SERVICE BULLETIN

APPLICABILITY: 2013-14MY BRZ

NUMBER: 12-200-16

SUBJECT: Rear Combination Lamp and Related Enhancements

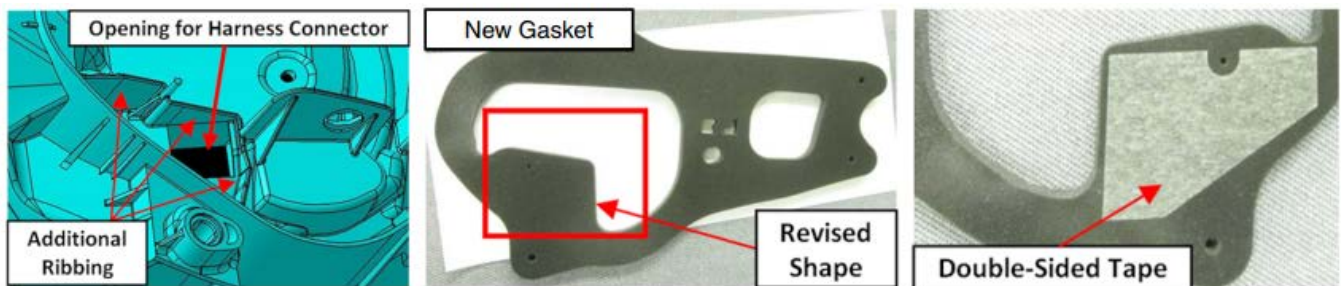
- Flange surface dimension of retaining nuts increased from 12mm to 15mm.
- Thickness of the combination lamp gaskets increased for improved sealing.
- The “height” of the trunk stoppers has been increased by 2.7mm and a liner added to the trunk weatherstrip intended to improve crush resistance and keep the trunk lid from contacting (and in a small number of cases, cracking) the tops of the combination lamps when closing.

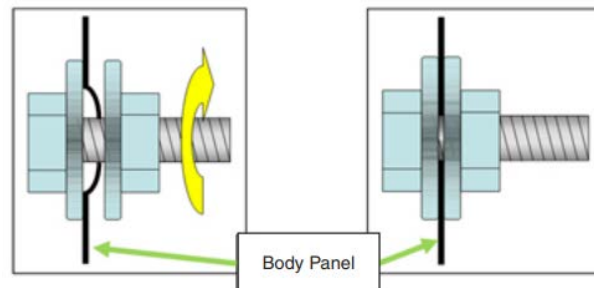
- Take out the 6 retaining clips from the trunk side liners then remove them to gain access to the combination lamp mounting nuts.
- After removing the 4 retaining nuts from each combination lamp, unplug and remove the assemblies.
- Before reinstalling any lamp assemblies, always inspect the rear body panel closely in the retaining nut areas for any deformation of the metal as shown in the illustrations below.

- If any deformation is found, **CAREFULLY** straighten the affected mounting area using a small body hammer and dolly.
- Another straightening method is to clamp the body panel using a bolt, flat washers and a nut as shown in the illustration below.

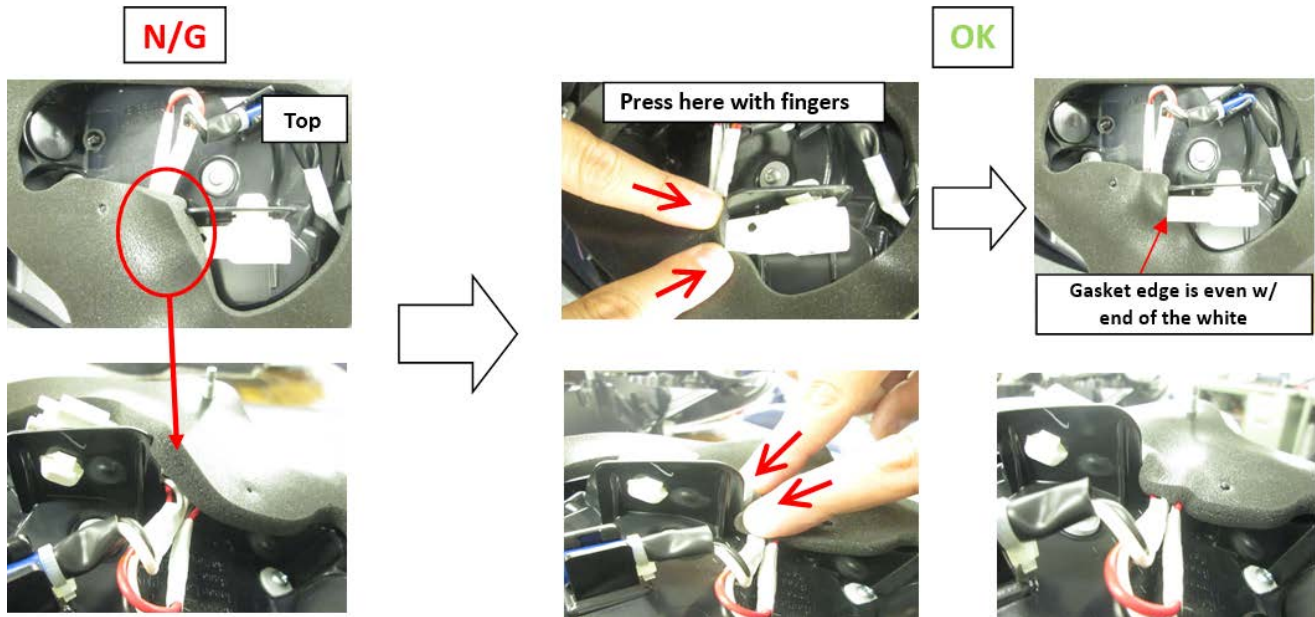
- Inspect the retaining stud boss areas of the housings for any cracking as shown below. If cracking is confirmed, the lamp assy. must be replaced.

NOTE: Unless the most recent combination lamp assemblies are already installed, when replacement is required, replace **BOTH** assemblies with the new parts.

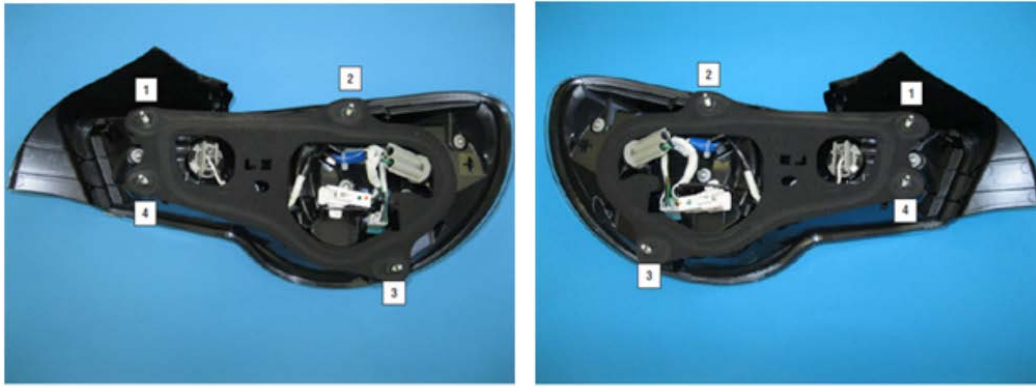
- The proper torque sequence must always be followed as shown in the photos below or damage to the combination lamp assembly may result. The torque specification for the retaining nuts is 4.5 Nm (39 inch-pounds).

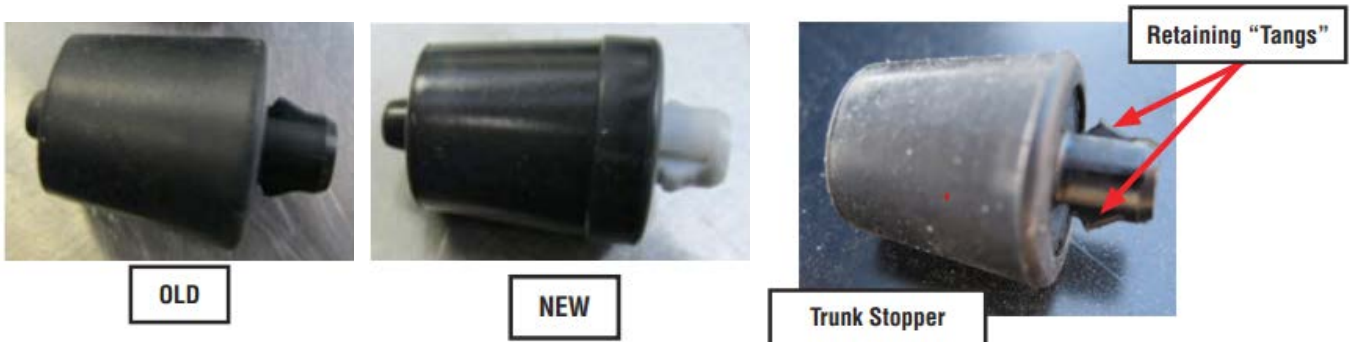
The photos below show the differences between the “OLD” and “NEW” trunk stoppers and the retaining tangs which secure them to the trunk lid.

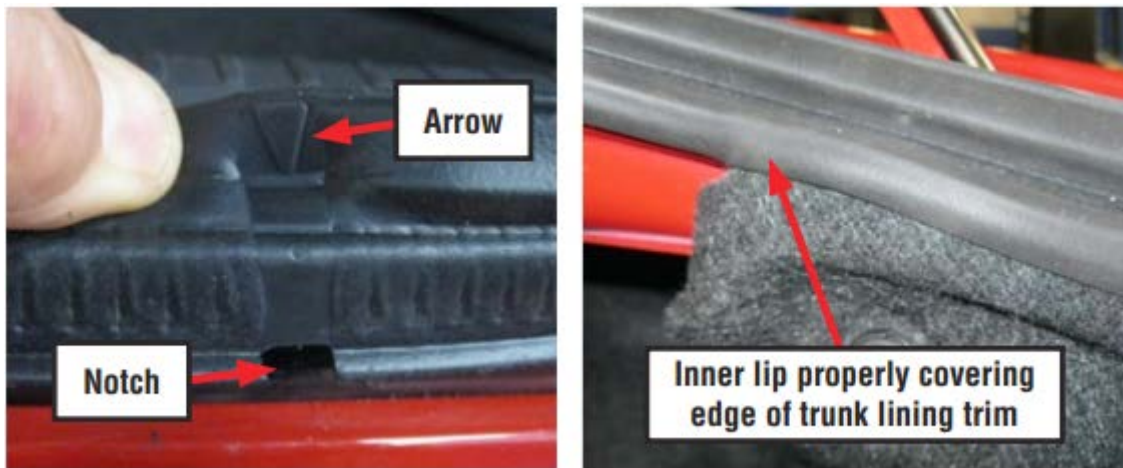
- To remove the trunk stoppers, use a plastic trim tool to lift up and release one of the retaining tangs. Once one side is released, hold the one side of the stopper away from the body then release the opposite tang with the plastic trim tool as shown in the photos below.
